Summary Reviews of Select Aspects of the USEPA Upper Hudson River Models

**Presented to the USEPA Baseline Modeling Report Peer Review Members
March 27, 2000**

**Quantitative Environmental Analysis, LLC
Montvale, NJ 07645**

Figure 1. USEPA (specified) and GE (calculated) relationships between effective settling speed and flow rate for the cohesive bed in the TIP.

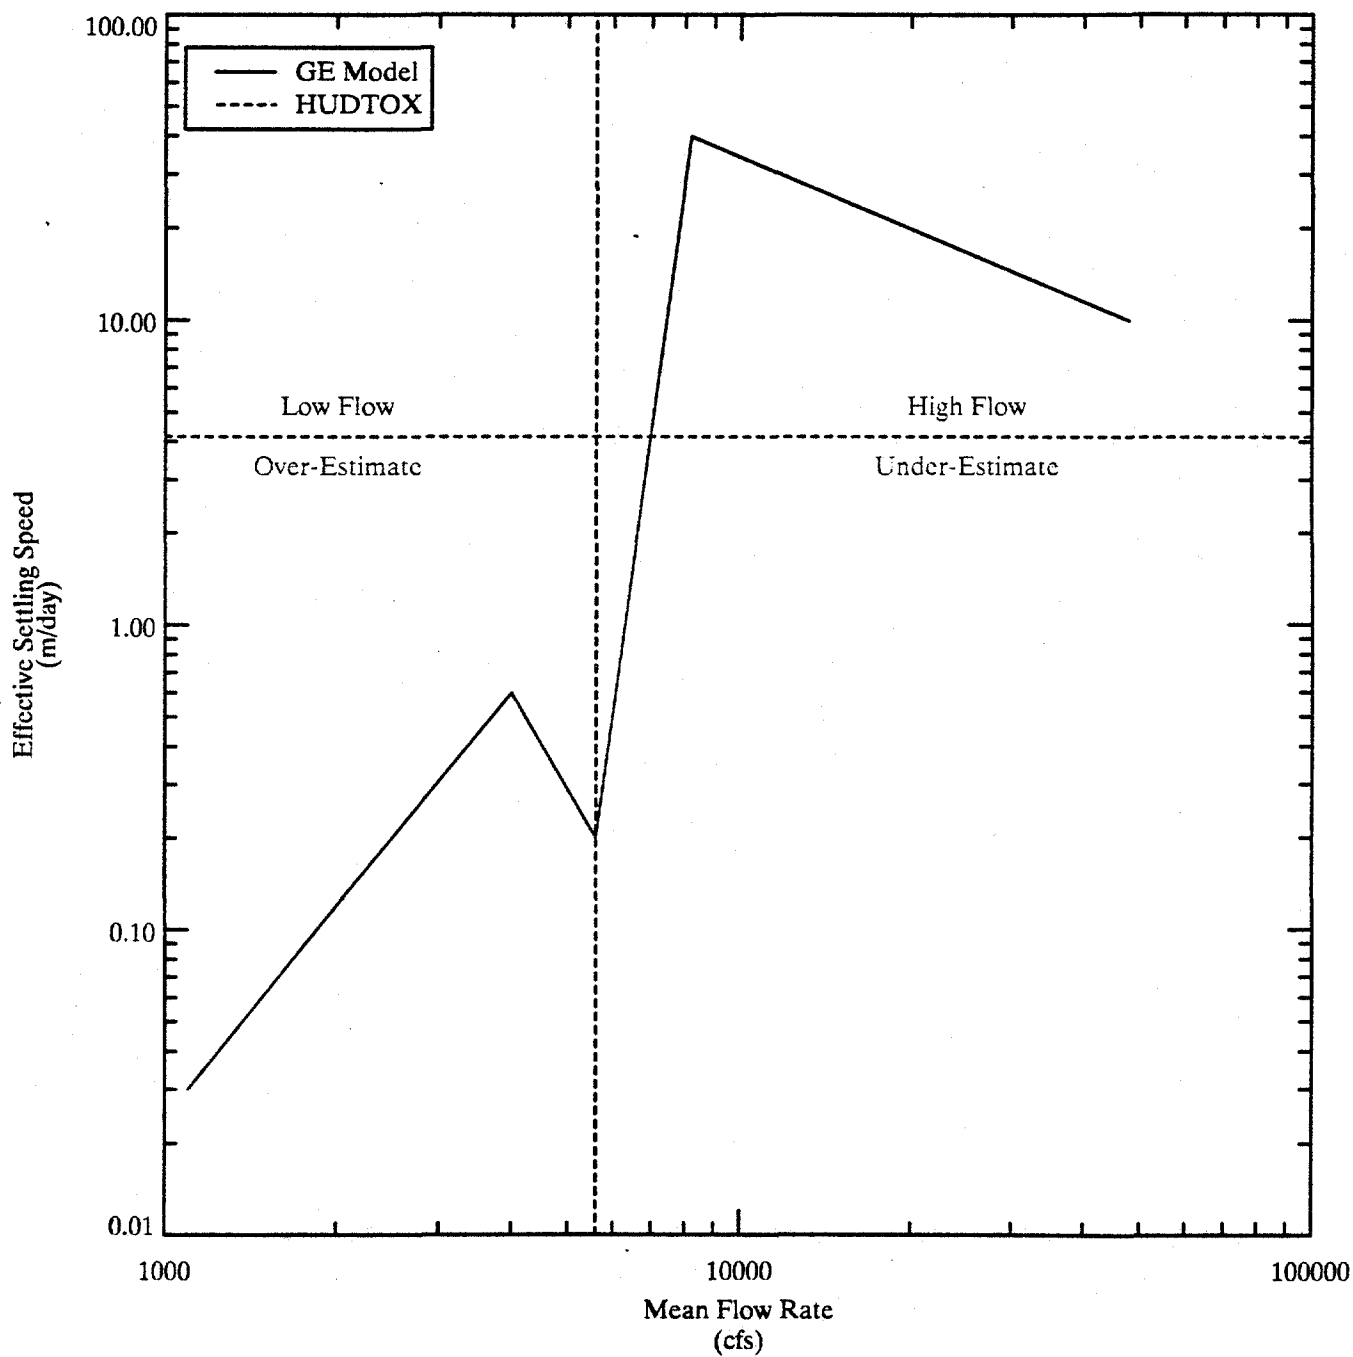
Similar deposition formulations were applied to cohesive and non-cohesive bed areas in HUDTOX. Effective settling speeds used in HUDTOX were temporally constant and spatially variable, with a higher value in cohesive areas than in non-cohesive areas. This approach overlooked three important phenomena that affect deposition: 1) variable bottom shear stress or, equivalently, flow rate (i.e., probability of deposition effects); 2) changes in composition of water column solids (i.e., relative amounts of clay, silt and sand in suspension); and 3) flocculation of clay and silt particles. An example of these effects on effective settling speed is illustrated in Figure 1, which shows results from the GE sediment transport model (a mechanistic model that USEPA has accepted) for a cohesive bed area in the TIP (QEA 1999). The effective settling speed relationship shown on Figure 1 is typical for the UHR, with relatively low settling speeds during low-flow conditions due to most of the suspended load being composed of flocculating clay and silt particles. During high-flows, significant increases in suspended sand content occur, causing the effective settling speed to increase by more than an order of magnitude. Even though the HUDTOX effective settling speed for cohesive bed areas (4.15 m/day) may approximate a long-term average value, it is too high during low-flow and too low during high-flow (Figure 1).

Figure 2. Total discharge and sediment loads input to tributaries in Schuylerville - Stillwater reach.

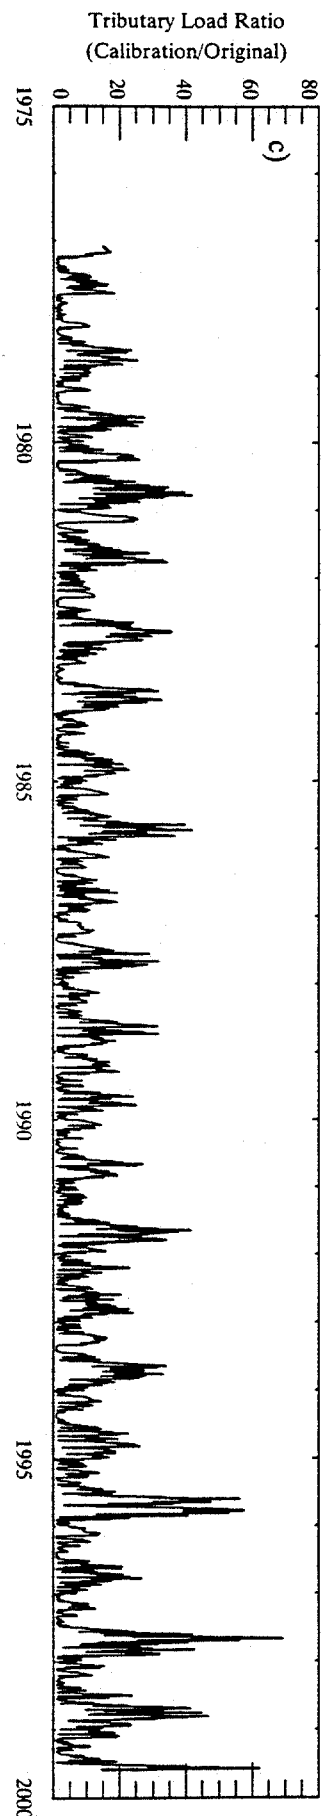
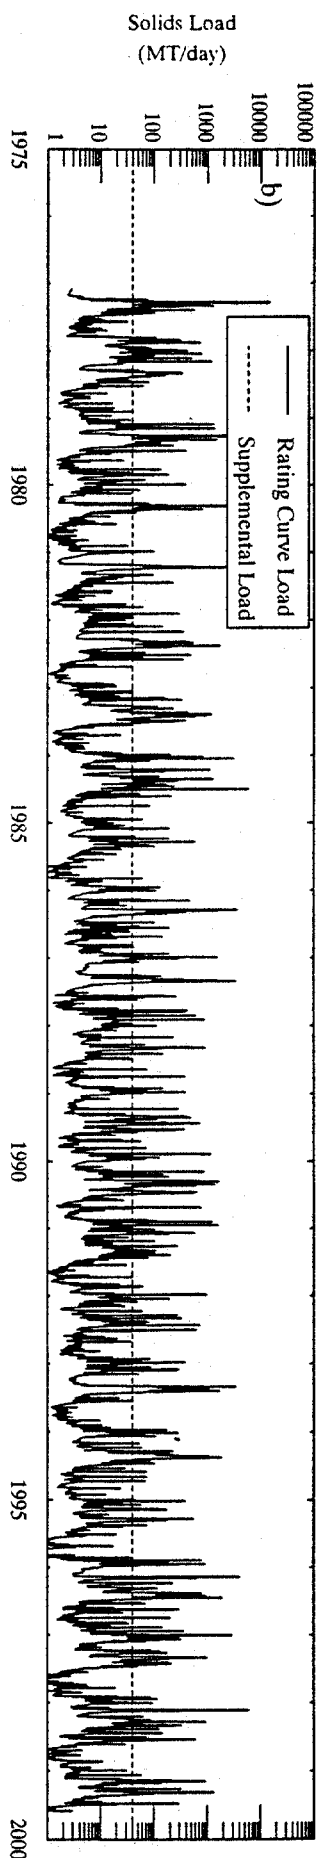
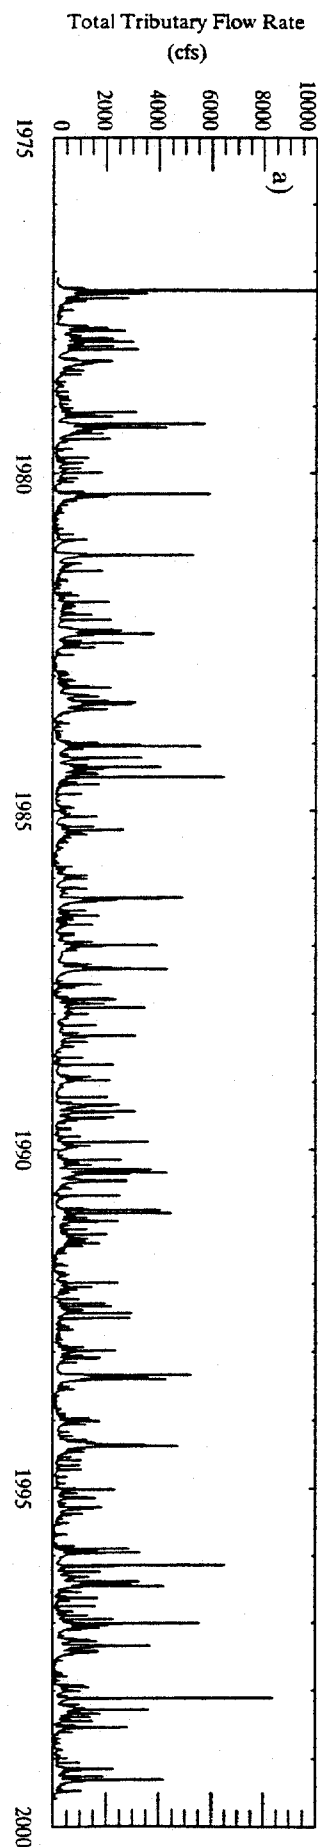
To calibrate its model, USEPA adjusted solids loadings from the tributaries downstream of the TIP (USEPA 2000), especially during low-flow conditions. Unfortunately, the RBMR does not provide sufficient information to determine the cause and extent of the initial calibration difficulties. Thus, USEPA input an additional tributary solids load of 40 metric tons/day (MT/day) to both the Schuylerville-Stillwater and Stillwater-Waterford reaches during the final calibration. Although USEPA portrays this load increase as being within the uncertainty range of the estimated tributary loads (USEPA 2000), a closer examination reveals that the magnitude of the supplemental solids loading was not trivial during low-flow periods, i.e., below mean tributary flow rate. While the increase in long-term solids loading was about 26 and 17% for the two reaches, respectively (USEPA 2000), the relative increase in tributary solids loading was much greater during low-flow conditions. Figure 2b shows a temporal comparison of the tributary loading for the Schuylerville-Stillwater reach specified by: 1) time-variable rating curves (developed from the solids load analysis referenced above and used during initial model calibration) and 2) constant load of 40 MT/day. During low-flow conditions, the supplemental load is significantly greater than the original rating curve load. The magnitude of this disparity in the Schuylerville-Stillwater reach is illustrated in Figure 2c, which shows the temporal variation of the ratio of the final calibration rating curve loading (initial rating curve load plus supplemental load) to the initial rating curve loading. This ratio increases as the flow decreases, with maximum values of about 70X and 12X for the Schuylerville-Stillwater and Stillwater-Waterford reaches, respectively. The ratio is greater than two 83% of the time between 1977 and 1999 for the Schuylerville-Stillwater reach. Assuming that uncertainty about the rating-curve-estimated loading is about a factor of two, then this percentage represents the portion of

time during which the assumption of a constant supplemental solids loading of 40 MT/day is **not** within the assumed uncertainty range of the tributary solids loading.

Figure 3. Comparison of supplemental load effects to original rating curve and TIP tributary data for direct drainage area in Schuylerville - Stillwater reach. Flow rates are normalized with respect to mean flow in tributary.

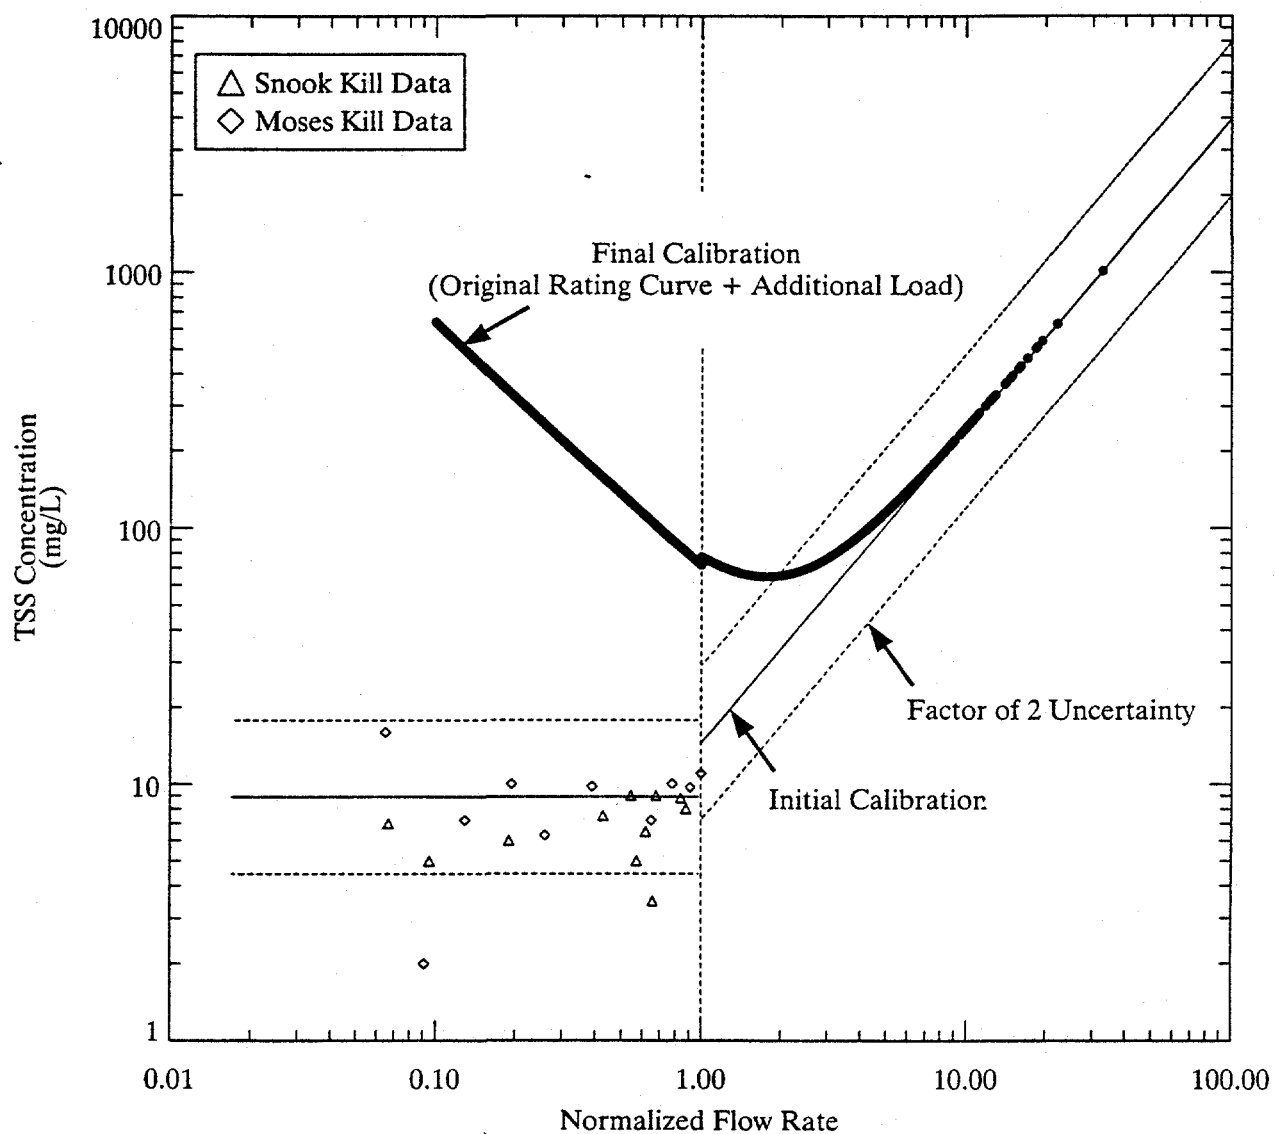
Analysis of tributary TSS concentrations required to produce an additional load of 40 MT/day provides a further illustration that this loading was unrealistic during low-flow conditions. With the additional load, low-flow TSS concentrations were as high as 500 and 190 mg/l for the Schuylerville-Stillwater and Stillwater-Waterford reaches, respectively. These concentrations are much higher than observed TSS concentrations during low-flow periods for UHR tributaries. Further illustration of the unrealistically high TSS concentrations resulting from the additional tributary load is presented on Figure 3 for the direct drainage area in the Schuylerville-Stillwater reach. This figure shows TSS concentration as a function of flow rate determined from three sources: 1) original rating curve (with factor of two uncertainty range); 2) additional constant load (18 MT/day for this tributary); and 3) low-flow TSS data for Snook and Moses Kill. Clearly, the additional load produced unrealistically high TSS concentrations during low-flow conditions.

Figure 1. Comparison of fish growth rates, fish lipid content and sediment organic carbon contents used in FISHRAND with measured values.

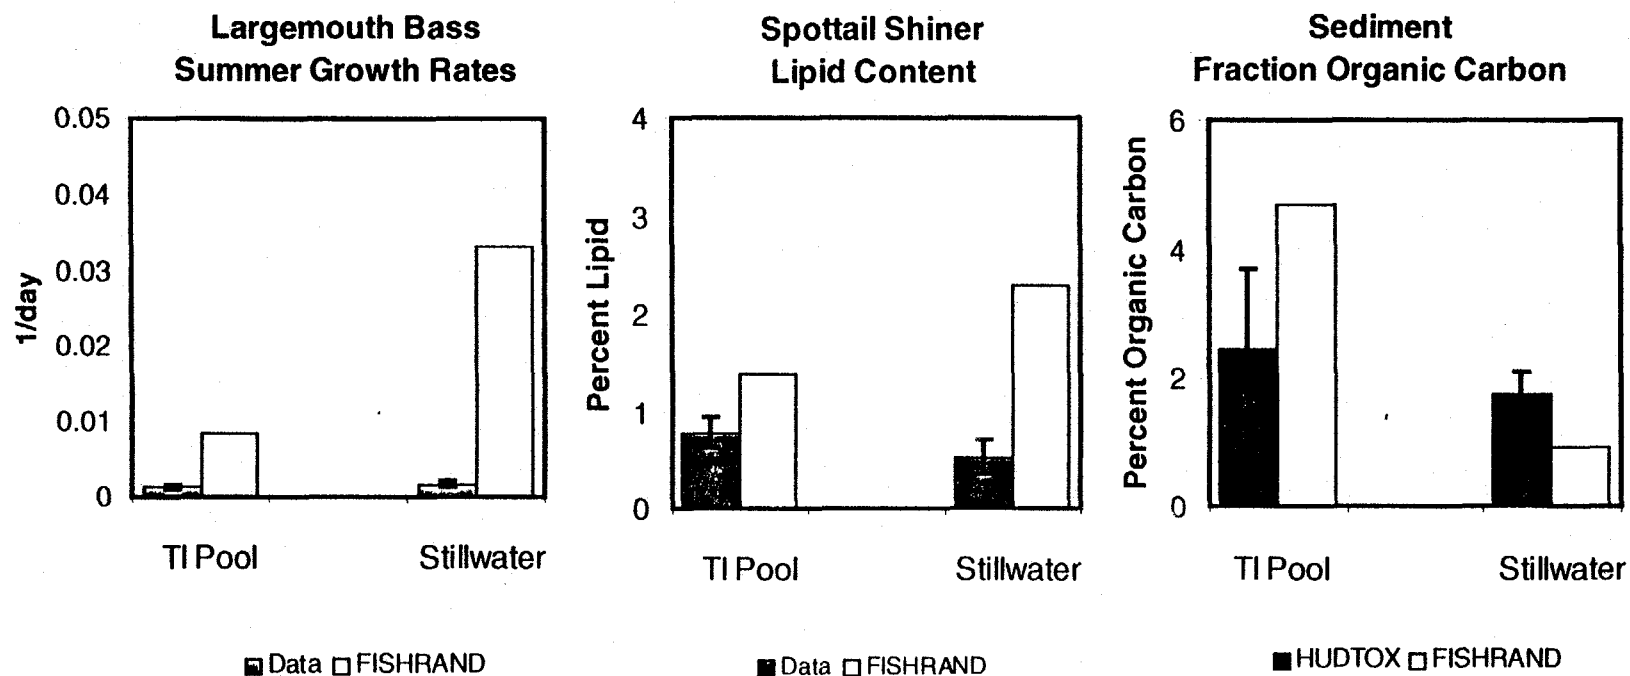
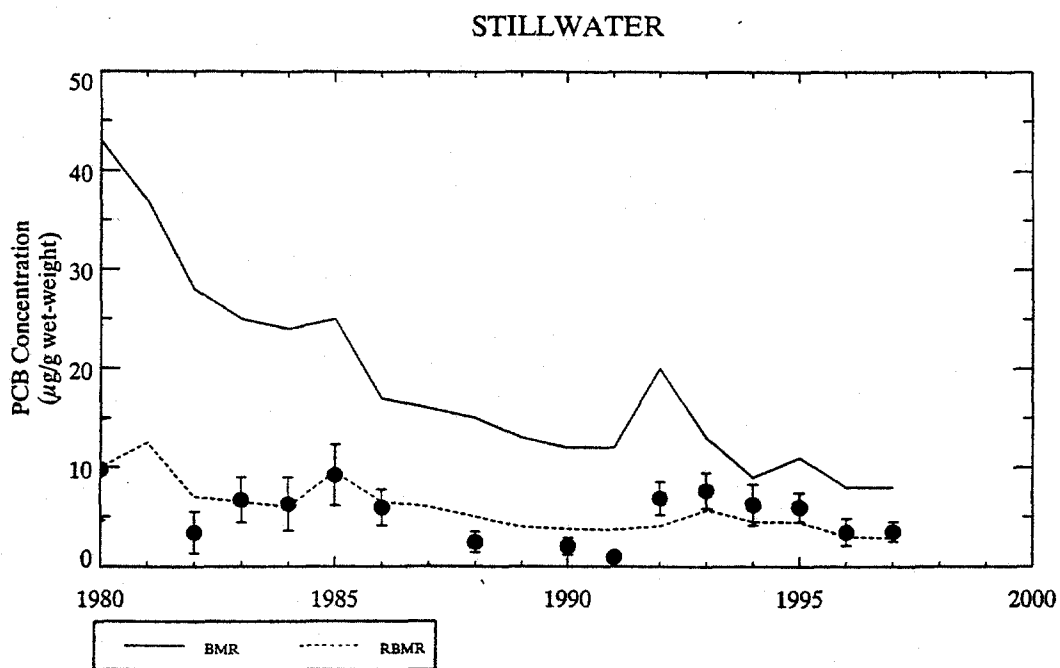
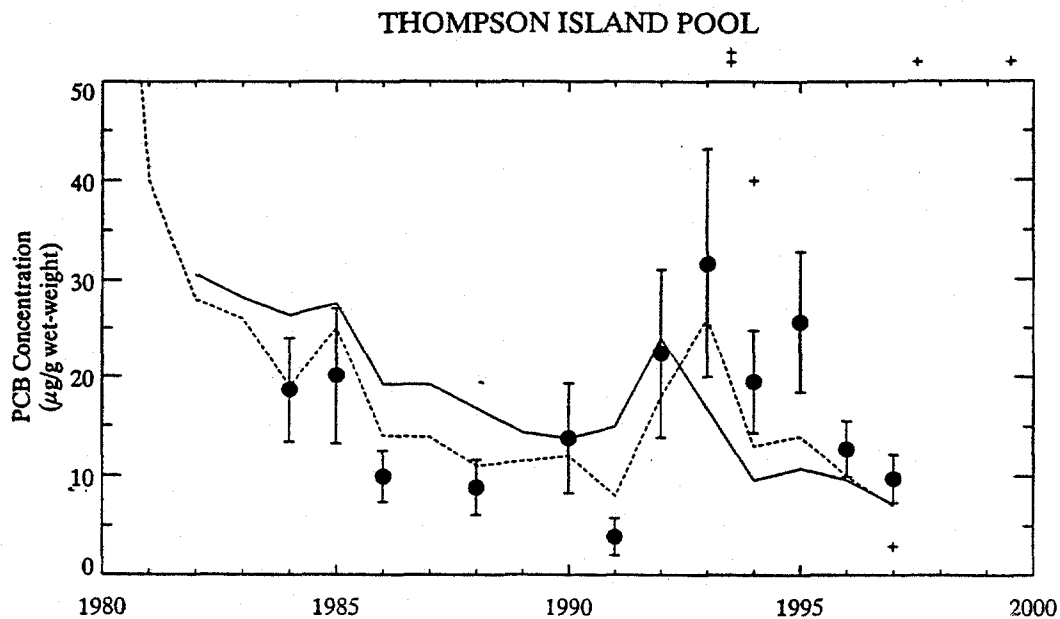
USEPA's model framework includes a default weight-based relationship for estimating growth rates. During calibration, USEPA modified a default parameter of this relationship on a species- and reach-specific basis, with no supporting analyses. USEPA did not consider site-specific growth data collected by the NYSDEC and others in the Upper Hudson River. The calibration adjustments result in largemouth bass growth rates in Thompson Island Pool and Stillwater that are 6 and 19 times greater, respectively, than indicated by the data. (Figure 1; Volume 2D, Book 4, Tables 6-2 and 6-3). Thus, not only are the growth rates at variance with the data, they were determined independently for each reach of the river. Growth rates of the other modeled species were modified in a similar manner (Volume 2D, Book 4, tables 6-2 and 6-3).

There are three problems with USEPA's estimation of fish lipid contents. First, calibration resulted in lipid contents different from the best estimates based upon the data collected by NYSDEC in during their PCB monitoring program. For example, the fraction lipid in the largemouth bass used at Stillwater (geometric mean = 0.006 g lipid/g wet weight) is less than ½ of the mode of the data (0.014). In contrast, a value more similar to the data (0.011) is used in Thompson Island Pool. Lipid contents for the other modeled species are also modified independently of the data and independently for each reach, for example spottail shiner (Figure 1).

The organic carbon contents of the sediments (f_{OC}) used in the calibrated model differ from the values used in HUDTOX, which are based upon the 1991 GE sediment data (Volume 2D, Book 1, p. 109; Book 2, Table 6-32). The f_{OC} values used in Thompson Island Pool and Stillwater are approximately twice and $\frac{1}{2}$ the average values used in HUDTOX, respectively (Figure 1). Using a lower carbon content at Stillwater increases the carbon-based PCB concentration, resulting in greater accumulation throughout the food web and a greater contribution of sediment-based PCBs to the food web. In effect, PCBs in Thompson Island Pool and Stillwater sediments are assumed to be $\frac{1}{2}$ and twice as bioavailable as the organic carbon data indicate, respectively.
